TECHNICAL SERVICE BULLETIN

Transmission Fluid Cooler Tubes Leaking At Transmission Case

24-232722 October
2024**Model:**

Ford 2020-2022 Mustang Shelby GT500

Figure 4

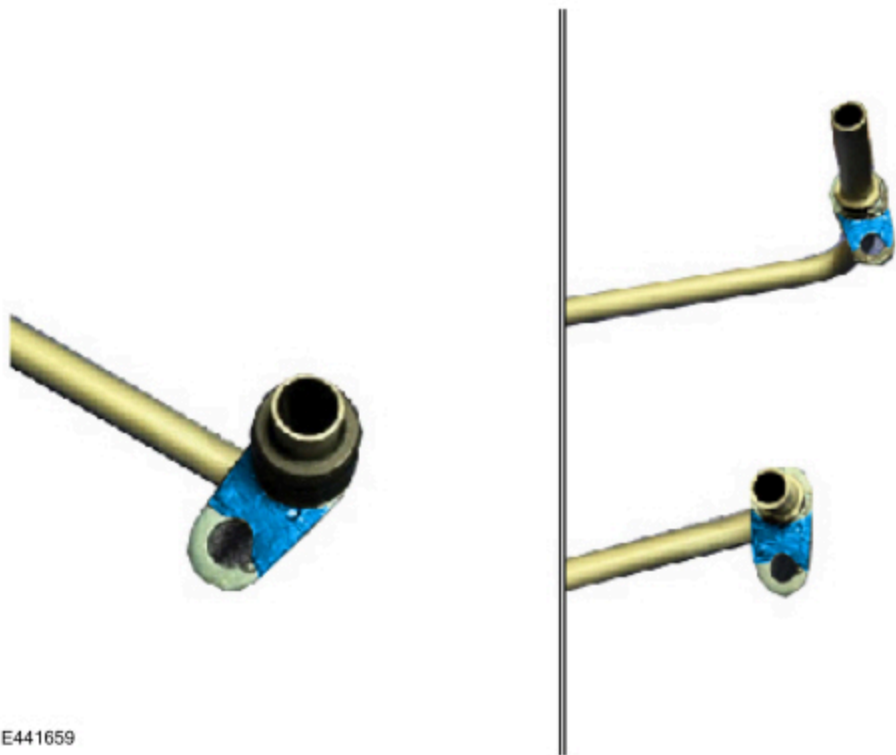
(4). Apply Motorcraft® Anti-Corrosion Coating with small brush and make sure all bare metal is covered. Coating must be dry to touch before proceeding to Step 3. (Figure 4)

Figure 5

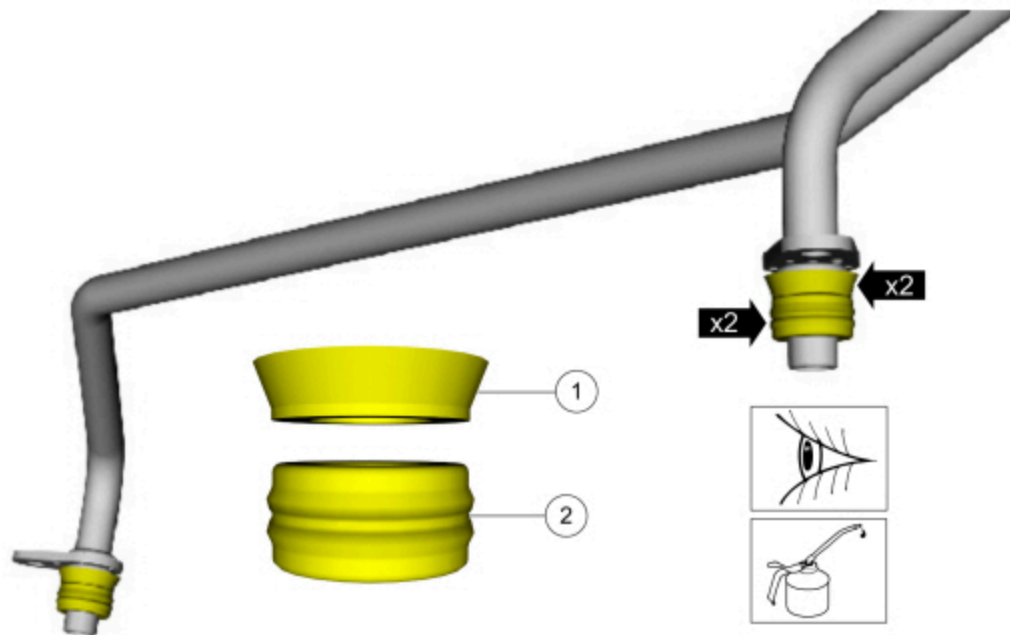
(1). Inspect, lubricate, and install the band seals and backing rings onto the line set. (Figure 5)

Figure 6

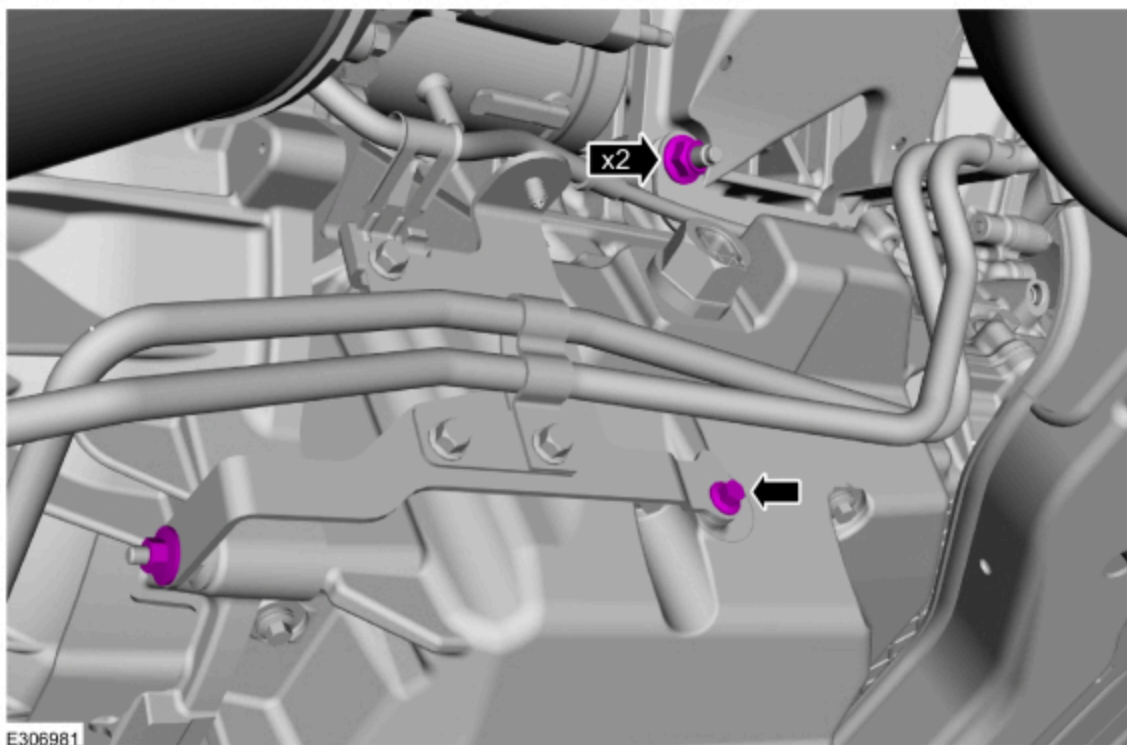
(2). Install the fluid cooler tubes bracket retainers but do not tighten. (Figure 6)

Figure 8

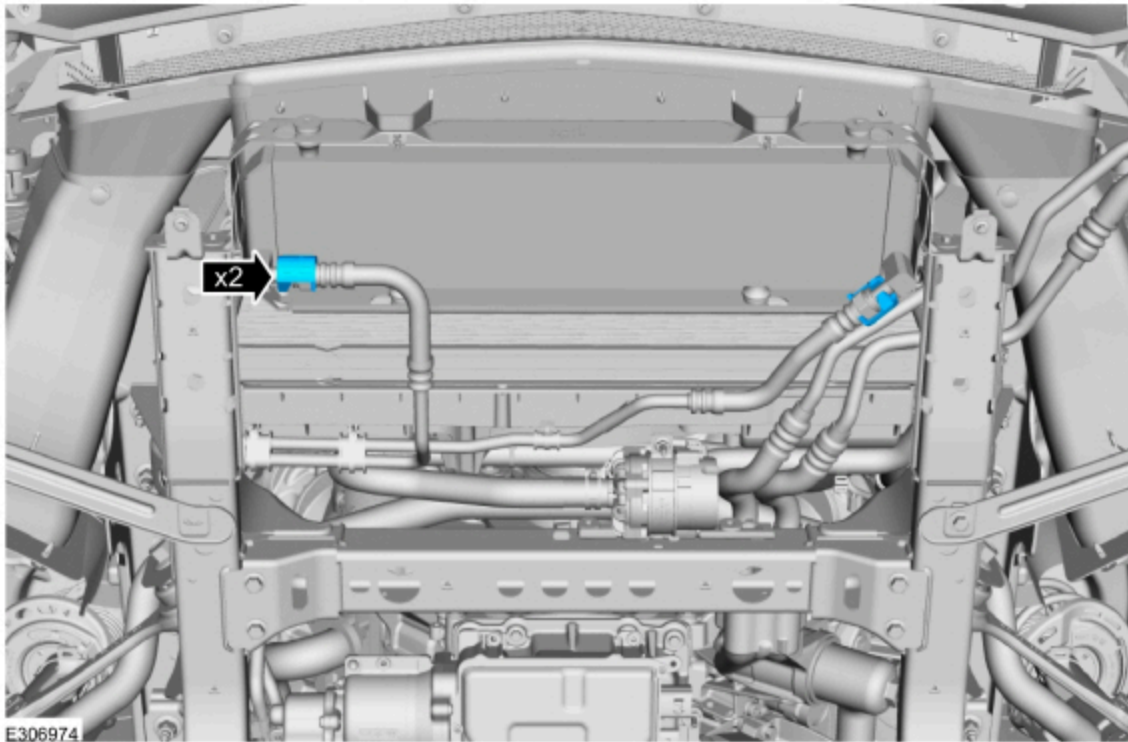
(5). Install the transmission fluid cooler tubes secondary latches. (Figure 8)

Figure 9

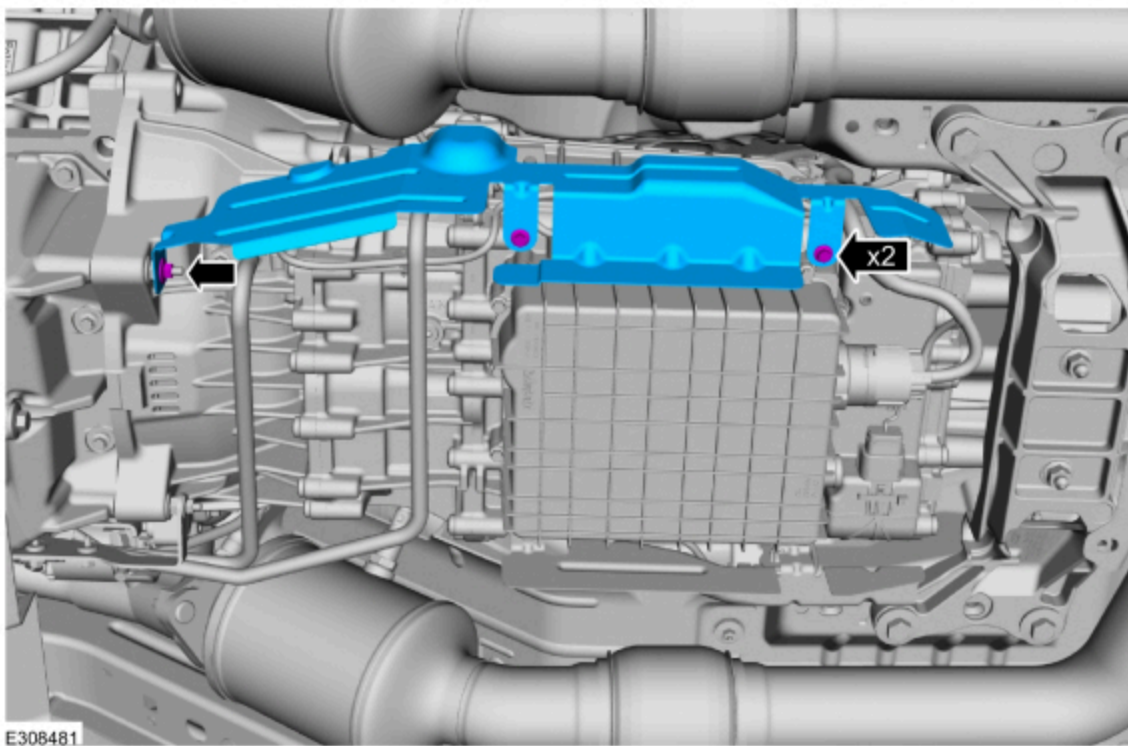
(8). Install the transmission heat shield and tighten the retainers nut to 53 lb.in (6 Nm), and bolts to 62 lb.in (7 Nm) (Figure 9)
